# **Intel® Pentium® M Processor, Intel® 855GME Chipset, and Intel® 6300ESB ICH Development Kit**

**Specification Update**

*July 2005*

**Figure 1. Missing Resistor (R5B5) Location**

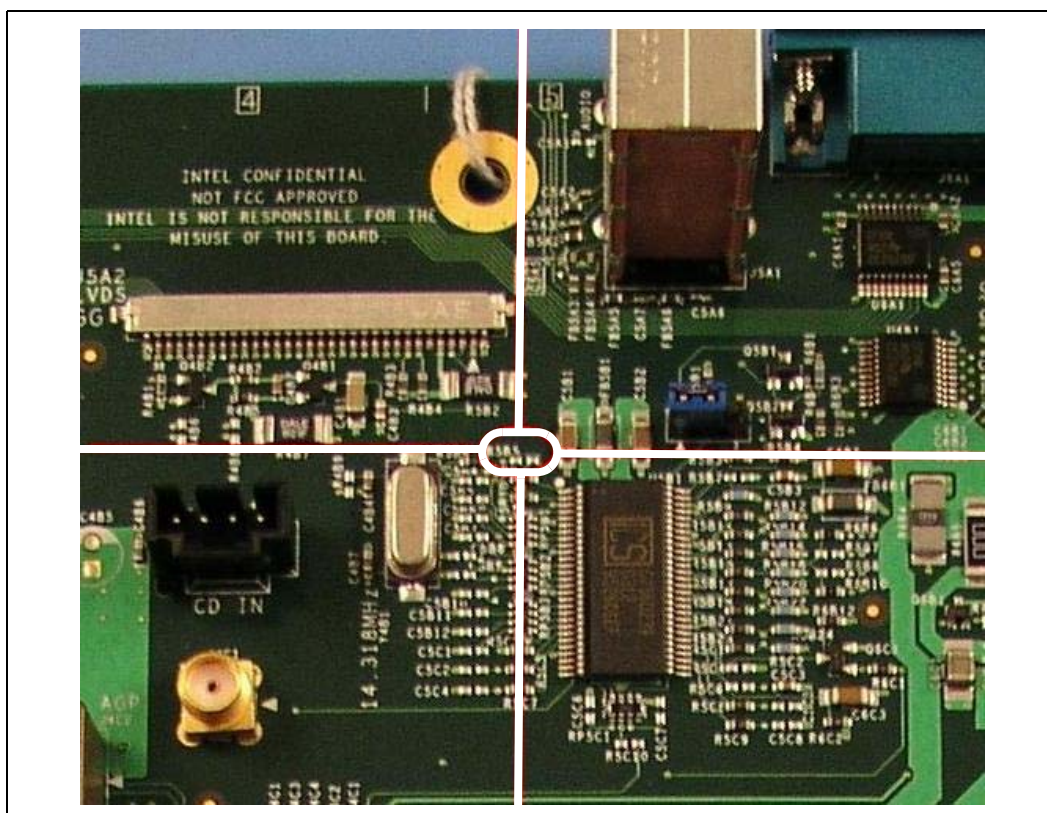
**Problem:** A manufacturing issue resulted in a missing series resistor on the AC'97 clock on certain boards.

**Implication:** Affected boards may not load AC'97 sound drivers properly; resulting in non-operational AC'97 audio.

**Workaround:** Inspect board for the missing 33 ohm, 0603 resistor (R5B5), as identified in Figure 1. If this resistor is missing, please contact your local Intel representative for RMA instructions.

**Status:** Fixed.
